Work Order ID 94496

Item Name: Replacement Float Skidtube w/ Full Length Wearplates & Wearpads

DRAWING NO. D3905		TITLE A119 FLOAT SKIDTUBE ASSY		REV. B		DART AEROSPACE LTD ENGINEERING ORDER		D.E.O. NO. D3905-B-1		SHEET NO. SHEET 1 OF 1		SCALE NTS	
DRAWN AJS		CHECKED [Signature]		MFG. APPR. [Signature]		APPROVED [Signature]		DE APPR. [Signature]					
DATE 12.10.30		DATE 12.10.30		DATE 12.10.30		DATE 12.10.30		DATE 12.10.30		DATE 12.10.30

MODIFICATION OF EXISTING DESIGN TO ALLOW INSTALLATION OF CROSSBOLT SPACERS FOR FORWARD GROUND HANDLING EQUIPMENT.

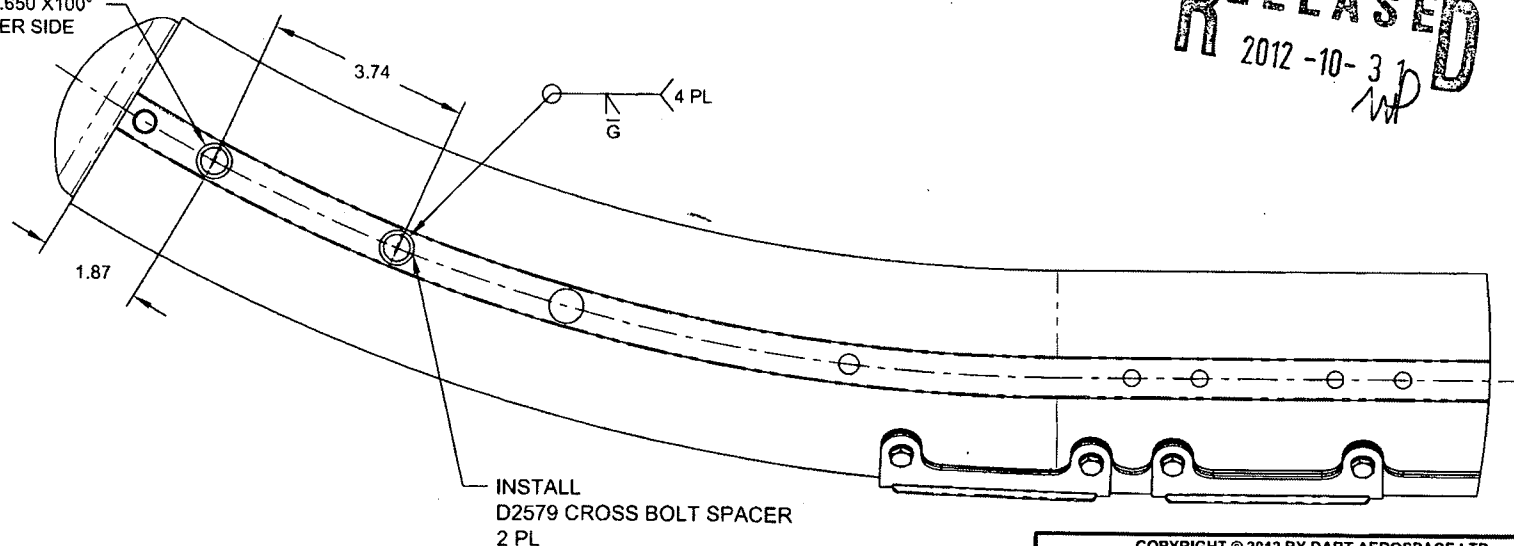
ADD THE FOLLOWING:

ADD THE DRILLING DETAIL BELOW TO DRILLING INFORMATION (SHEETS 5 & 6):

ADD CROSSBOLT SPACER INSTALLATION INFORMATION TO -041 THRU -045 (SHEETS 2 - 4):

DRILL Ø0.500 THRU
CSK Ø0.650 X100°
2 PL PER SIDE

FIGURE 1. MODIFIED D119-646-XXX SKIDTUBE

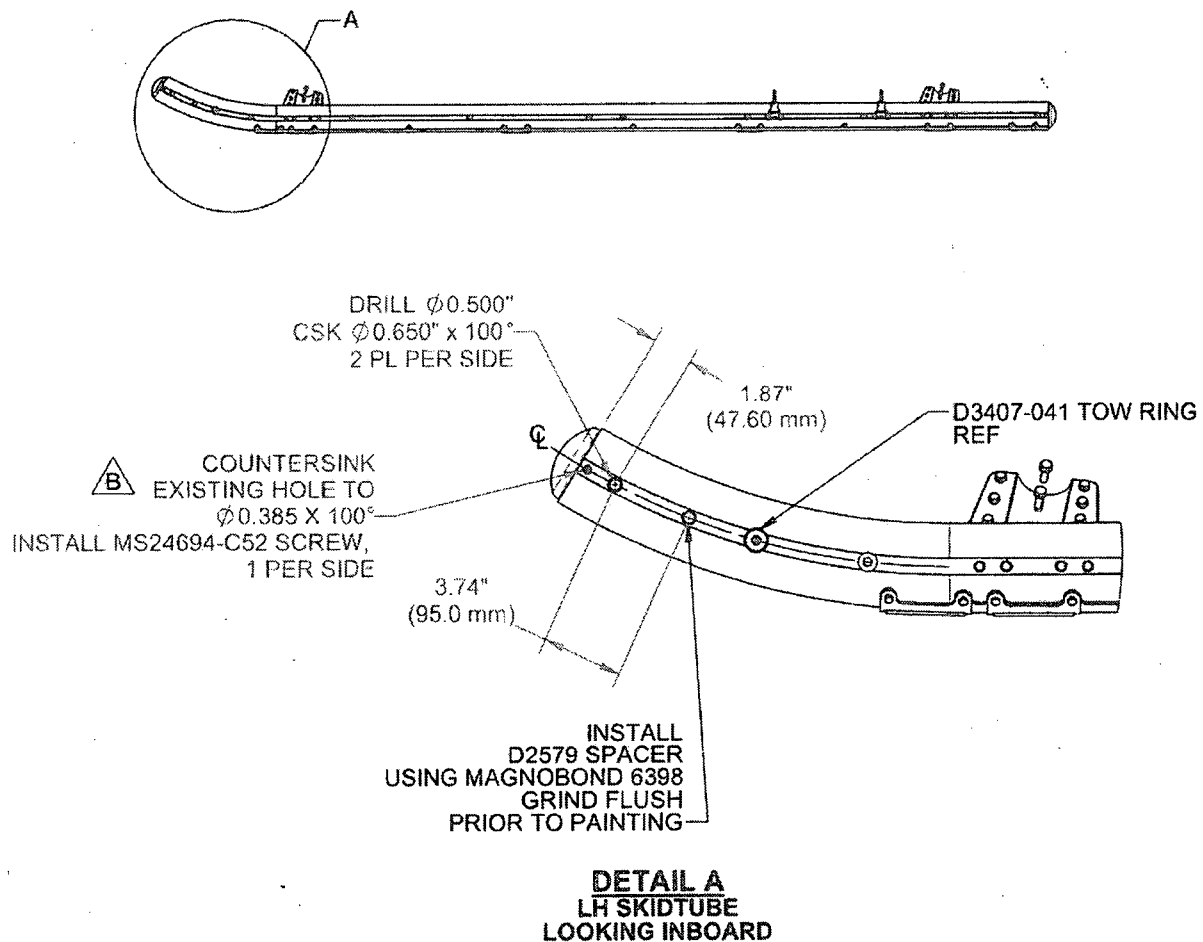
The purpose of this DSI is to provide instructions for customers to modify the forward end of the D119-646-XXX skidtubes using the DSI 9594-011 Kit to make the skidtubes compatible with the Agusta ground handling wheels. One kit modifies 2 skidtubes. After CHG 001, portions of this modification may have been incorporated in production and therefore will not need to be incorporated in the field.

- 2.1 Rotate the D3407-041 Tow Ring to the vertical position as necessary.
- 2.2 Mark holes in the center ridge as shown in Figure 1. Drill through skidtube with Ø0.500" (12.7 mm drill), and countersunk to Ø0.650 x 100°, two places per side.

- 2.3 Remove and discard the hardware retaining the forward Cap. Countersink the existing holes to Ø0.385 x 100°.
- 2.4 Deburr holes. Touch up affected areas with chemical film material (Alodine 1200 or 1201) per MIL-C-5541.

- 2.5 Bond D2579 spacers into the Ø0.500 holes center in the skidtube using Magnobond 6398. Grind flush prior painting as shown in Figure 1.
- 2.6 Apply one coat of MIL-P-85582 or MIL-P-2337 primer and 2-3 coats of MIL-C-83285 polyurethane coat to match original finish.
